Review of Grounded ridge detection and characterization along the Alaskan Arctic coastline using ICESat-2 surface height retrievals by Lange et al.

Grounded ridge detection and characterization along the Alaska Arctic coastline using ICESat-2 surface height retrievals

Submitted to The Cryosphere Discussions

<https://doi.org/10.5194/egusphere-2024-1885>

GEBCO Type ID Map

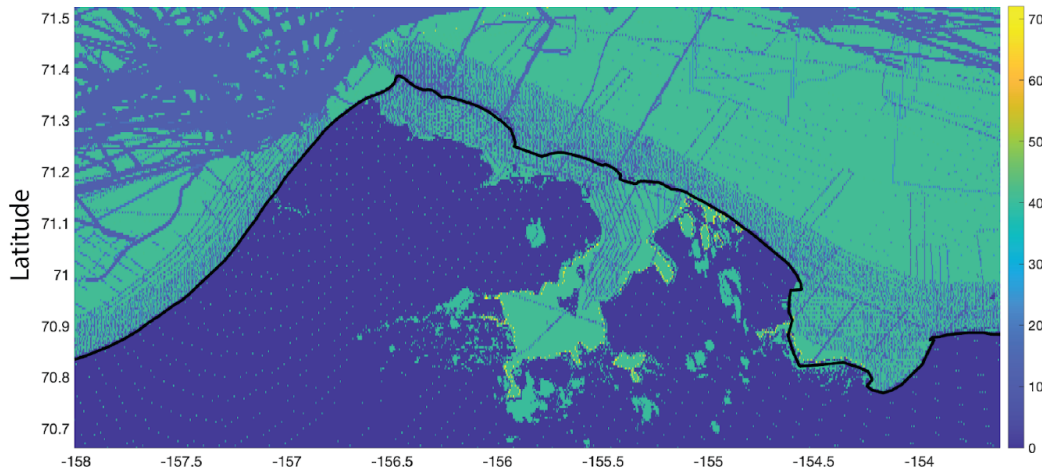
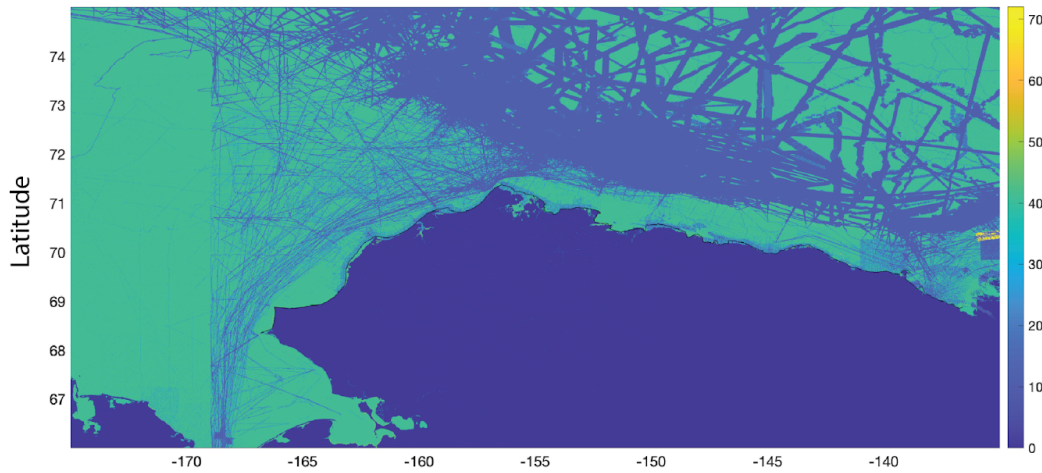
Given the sparsity of sounding points in shallow water and the year-to-year variability of the bathymetry in these regions, I am somewhat skeptical of the validity of using GEBCO bathymetric data all the way up to the coastline. The GEBCO Type Identifier (TID) Grid, available with GEBCO bathymetry data, show that broad areas of the Alaska coast shallower than ~5 m are coded with the value 41 which indicates the bathymetry values are “Interpolated based on a computer algorithm”. I would therefore recommend the authors exercise more caution when identifying grounded features in shallow water. The authors already exclude features in water shallower than the level ice draft, but I don’t understand the rationale for this (see comment 6). Instead, I recommend the authors establish a shallow-water cut-off value, based on the GEBCO TID Grid. This value might vary regionally according to the density of sounding points used in the GEBCO grid, but this would provide a data-driven rationale for excluding ridges in shallow water. Also, under the topic of bathymetric uncertainty, I don’t understand how the orange areas in Figures 4-7 were derived. Line 209 states “The orange shading represents positional uncertainty in the bathymetry line”, but the width of the orange shading would suggest that the positional uncertainty is on the order of hundreds of meters, which seems too high.

In the 2024 GEBCO product, the TID Grid does not identify shallow water areas as consistently interpolated (Type 41). We have included in this response a map of type identifiers both across northern Alaska and in the area around Utqiagvik and Elson Lagoon (following page). There are singlebeam depth measurements (Type 11) in shallow water (≤ 2 m) including in lagoon areas. GEBCO does not establish a shallow-water cutoff. In the revised paper, we note individual ridge detections in figures 5-8 as being either based on singlebeam depth measurements (* markers) or interpolated bathymetry (square markers).

That said, there certainly are issues with depth estimates at shallow water depths. In re-running the analysis we implement a general shallow water cutoff at 3m depth, which is grayed out in figures 6-8 and accounted for in the statistics presented in Table 1, figures 9-11, and the discussion in the results section.. This is in part due to the uncertainty in shallow water measurements, but generally to exclude features inside the lagoon areas. The orange bars in the original version of figures 4-7 reflected the 500m spatial resolution of the GEBCO product. We have removed these and instead address issues regarding the coarse spatial resolution of the GEBCO product in the discussion.
